St Marys Site Audit Report and Site Audit Statement for Validation Report

Sydney Metro Western Sydney Airport Station Boxes and Tunnelling Works

Project number	WSA-200-SBT
Document number	SMWSASBT-CPG-STM-SN100-EN-RPT-295307
Revision date	16 February 2024
Revision	01

SITE AUDIT REPORT

FIGURE 6
Unexpected Finds
St Marys Station

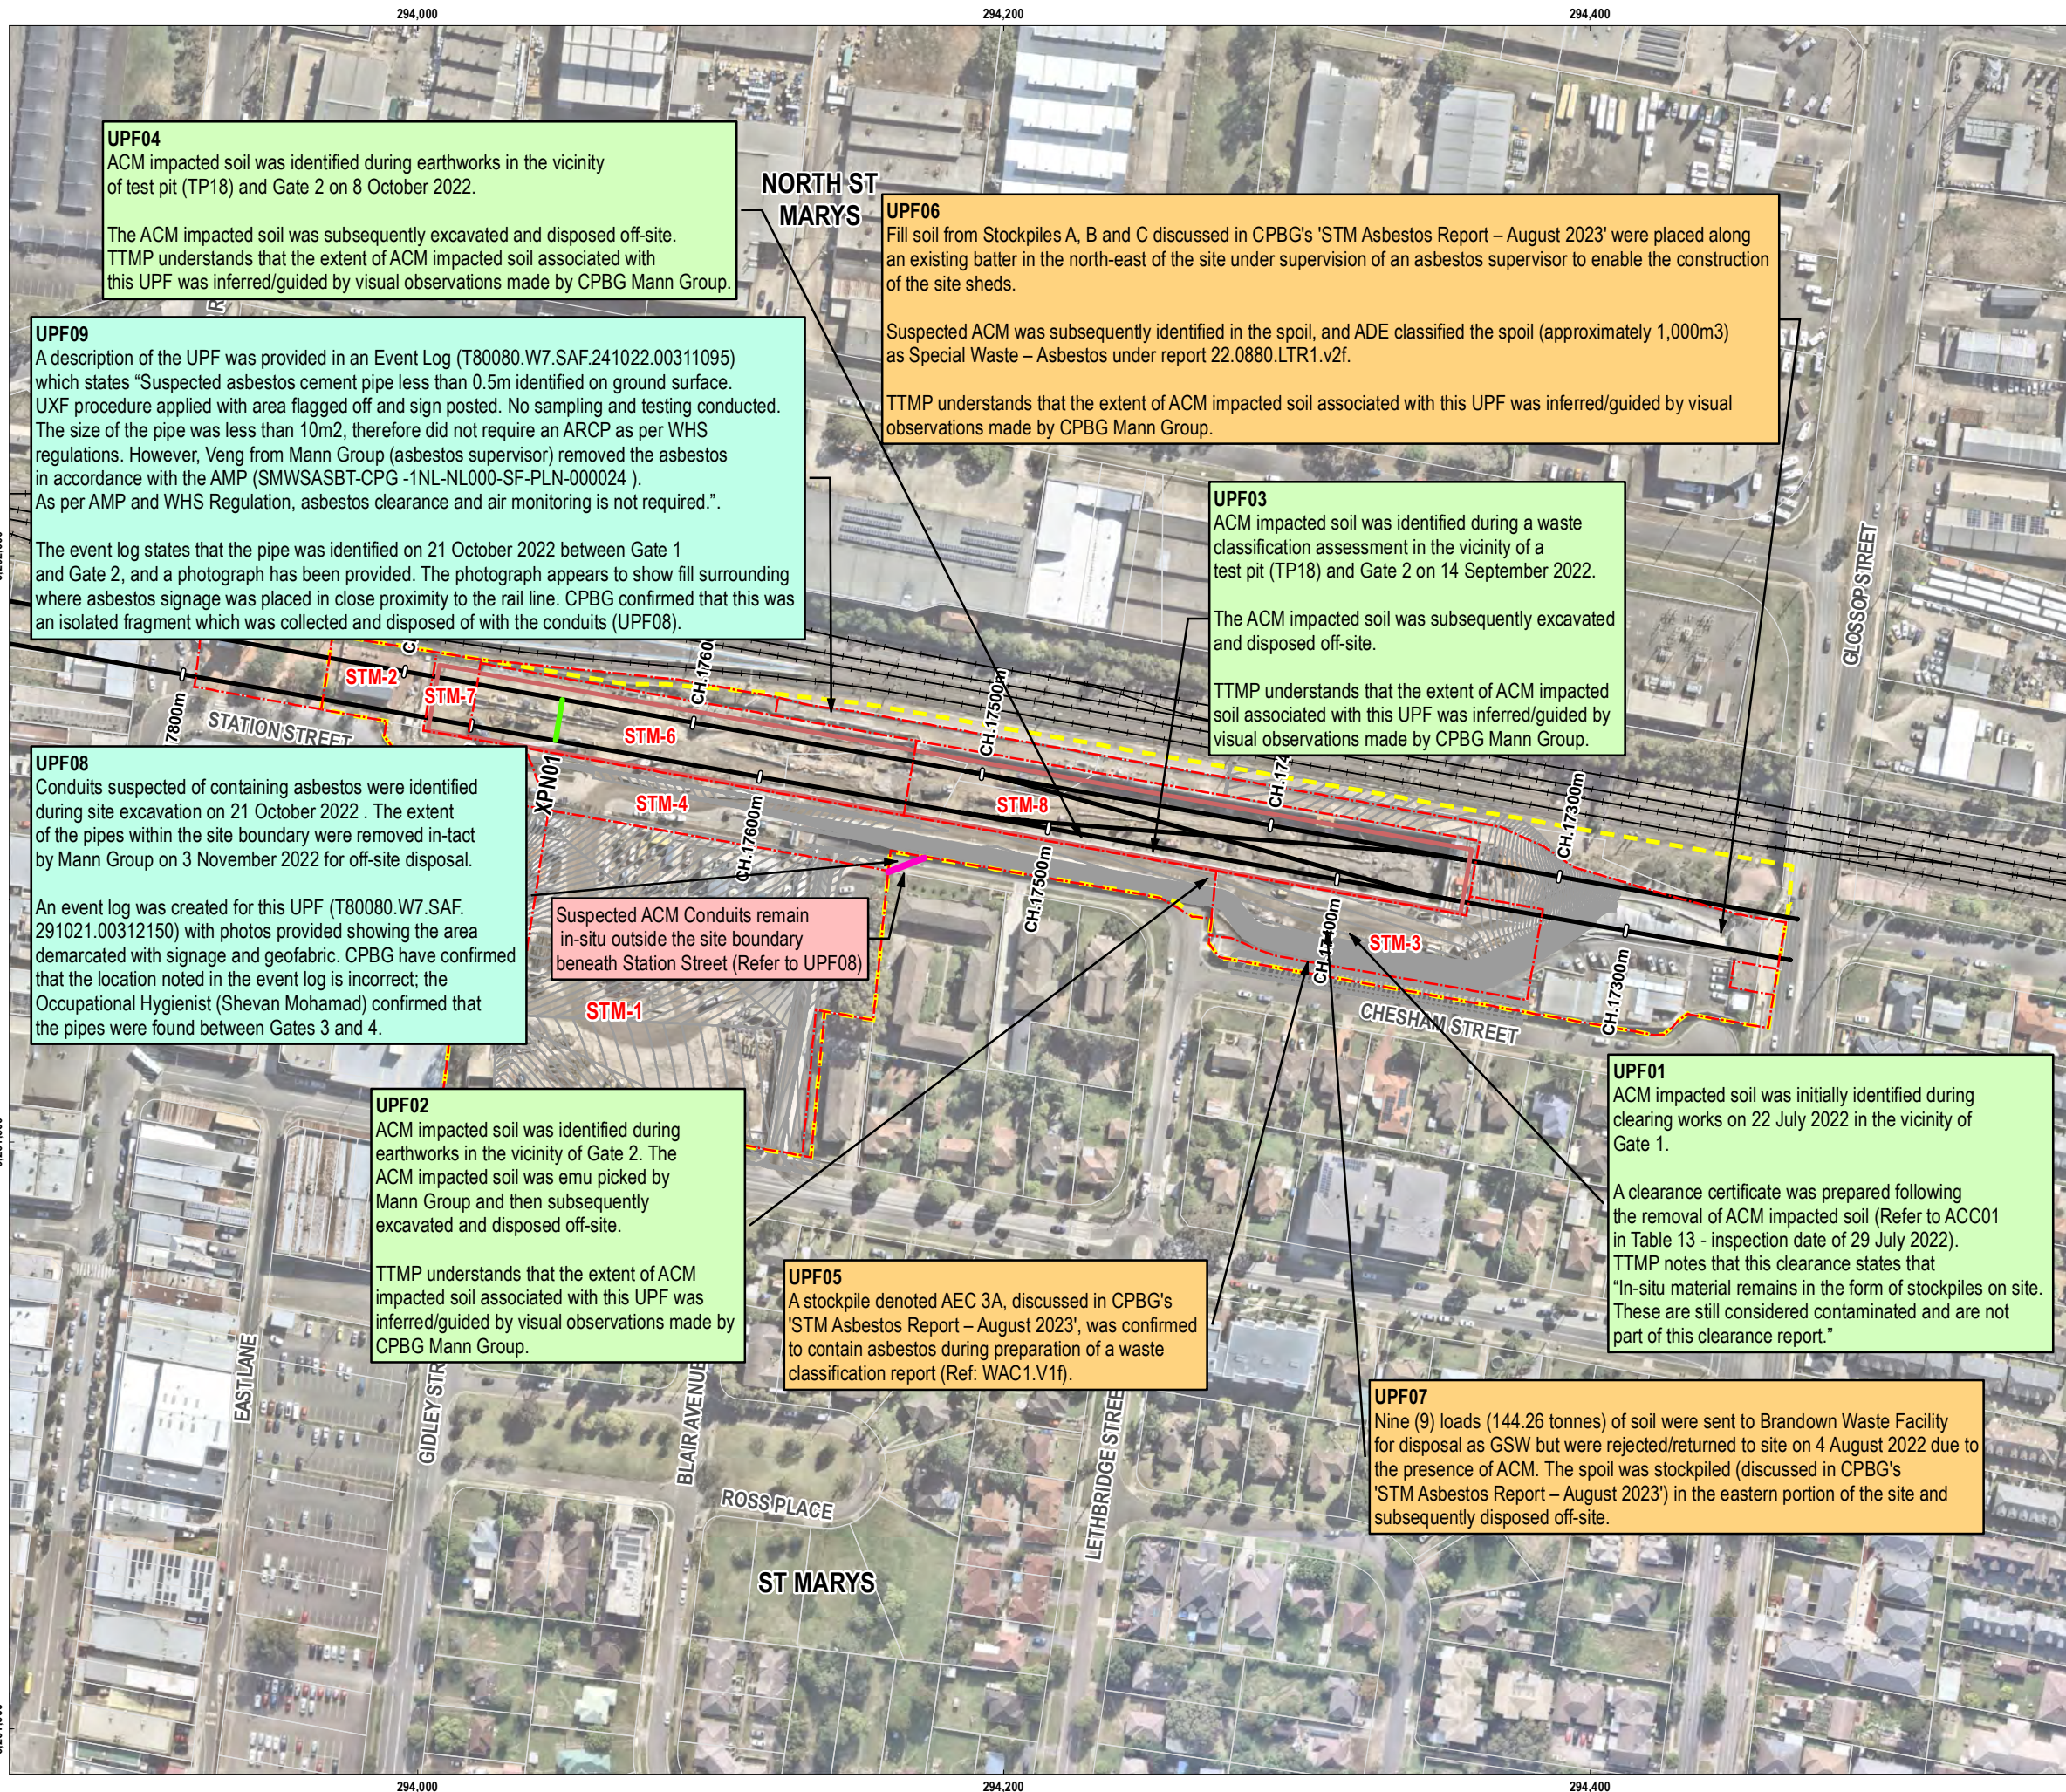
UPF04
ACM impacted soil was identified during earthworks in the vicinity of test pit (TP18) and Gate 2 on 8 October 2022.

The event log states that the pipe was identified on 21 October 2022 between Gate 1 and Gate 2, and a photograph has been provided. The photograph appears to show fill surrounding where asbestos signage was placed in close proximity to the rail line. CPBG confirmed that this was an isolated fragment which was collected and disposed of with the conduits (UPF08).
